Deadline 2 Representation to PINS on Sizewell C

Bill Parker
2nd June 2021

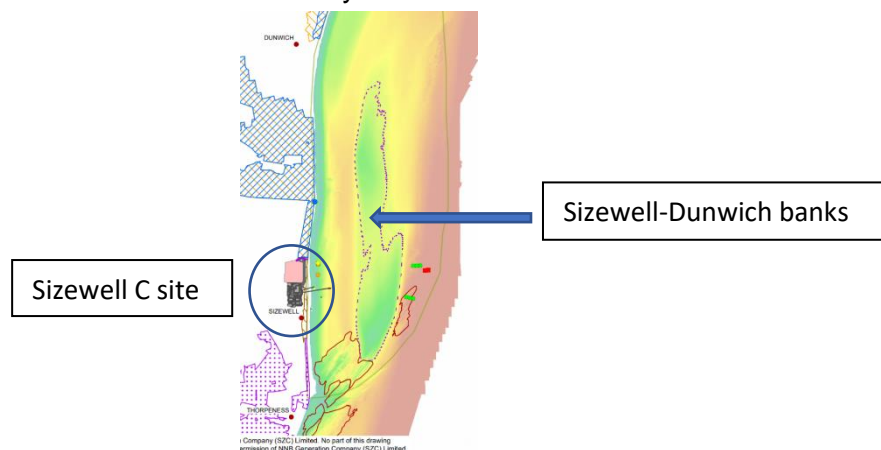
5.4.2. Sizewell A and B stations are located on a Crag outcrop whilst the proposed Sizewell C site is located on a former river bed on peaty material. Sizewell C site therefore has no natural protection from erosion and requires a built defence which will impact on natural coastal processes with long term consequences which are inadequately unexplained or mitigated for by EDF in their documentation.

5.4.3. Whilst it is acknowledged that the Crag offers some resilience, there has been no risk analysis (that I have found) into its vulnerability to increasing ocean acidification, warming or damage from more frequent and potentially violent storms. This appears to be a gap in the analysis.

Illustration 1: Heat map comparison in depth of water above the Dunwich and Sizewell Banks. Note the red spectrum is reducing water depth and the blue increasing water depth.

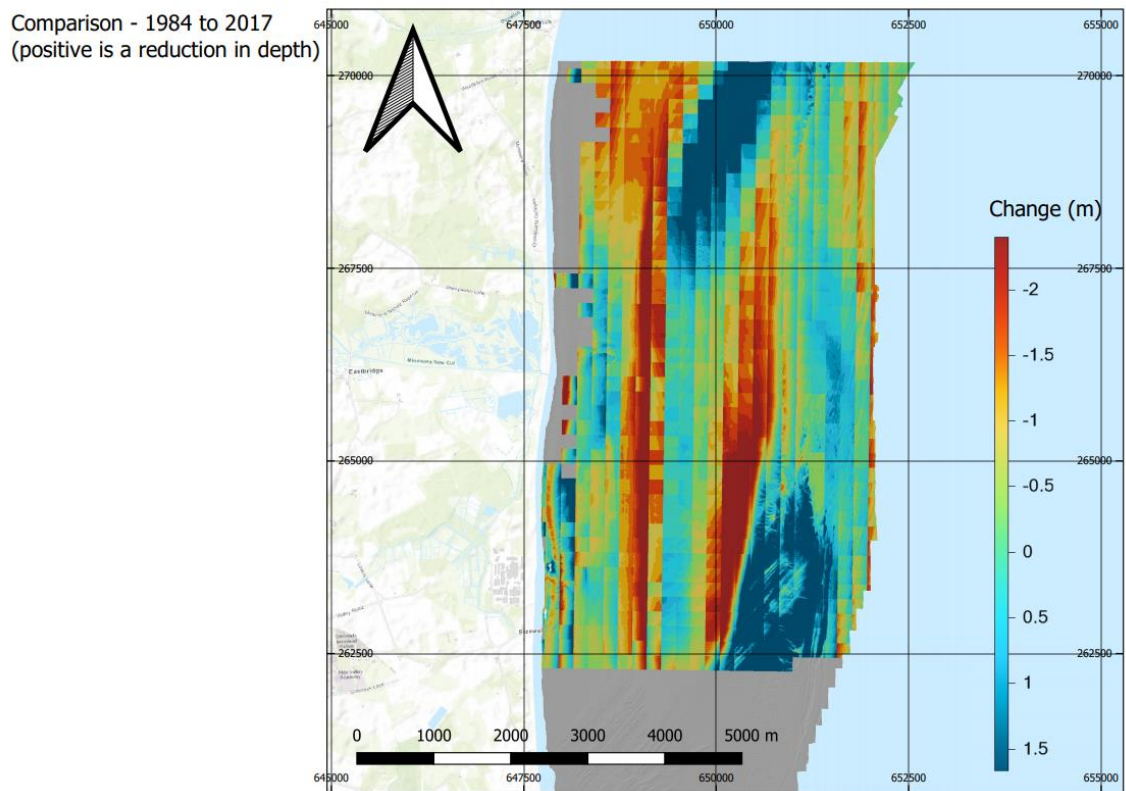
5.5.5. Evidence from Hydrographic Office bathymetric surveys in 1984 and 2017 identifies that the northern end of the Dunwich – Sizewell bank (made up of unconsolidated material) is shown to be migrating westwards and the saddle between the two banks can be seen to be flattening (ie increasing depth of water) and having a reduce impact on wave attenuation (i.e. a reduction in its effectiveness at reducing wave energy)

5.5.6. The movement and evolution of these sandbanks over time is not well understood especially over a decadal or 100-year timescale. Their inaccessibility and difficulties in surveying mean that the understanding of these control features is limited. However, the episodic spikes of erosion seen recently at Thorpeness (2 miles to the south of Sizewell) and Pakefield (14 miles north) has been attributed to changes in other near shore sand banks.

Figure 6: Sea frontage along the proposed Sizewell C

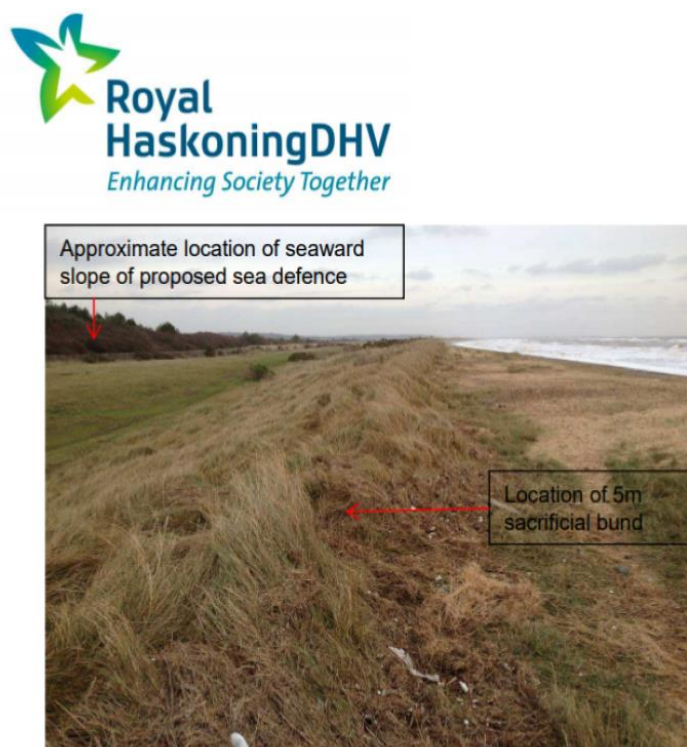
- 6.1.6. This image implies that the front edge of the hard defence is some distance from the edge of the beach. This image is designed to build confidence that the location of the rock slope is some distance from the beach and there is a wide area between the defence and the shoreline. This is clearly inaccurate and particularly with the planned increase in Hard Coast Defence height from 10.4 to 14.2m AOD which will need a bigger land take footprint. Perhaps a more accurate image would be as follows:

- 6.1.7. The ambiguous and evasive statements made by EDF / Cefas question what the real implications are for this part of the coastline and how acceptable it will be to local people.
